GREENSIDE LANDSCAPES Unit 45, Golds Business Park, Jenkins Drive, Elsenham, Essex, CM22 6JX			
CLIENT:			
ARCHITECT:			
SITE:			
Hornsey Town Hall			
TITLE:			
Typical Paving Application Town Hall Square – Detail 01–03			
SCALE AT A3:	DATE:	DRAWN:	CHECKED:
1: 20	16/07/20	LF	
PROJECT NO:	DRAWING NO:	REVISION:	
HTH_20	GSL_P2.02–002	C03

Detail 03
1:20 - Town Hall Square Planter Border

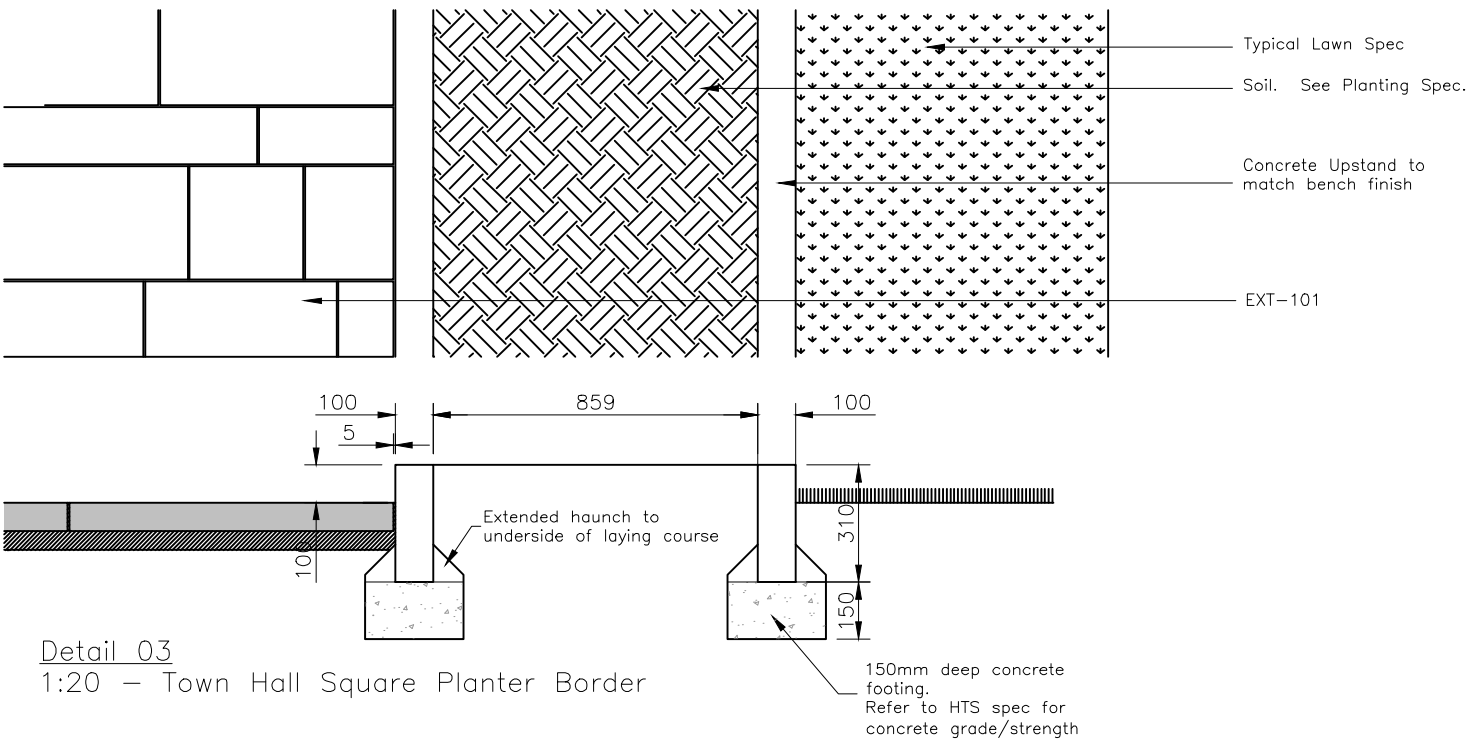
PLEASE NOTE That the design of the planter wall bedding which extends into the RPA needs to be agreed with arboriculturist. 150mm foundation proposal may not be achievable in some areas, so suggest review prior to works, to ensure design is permitted.
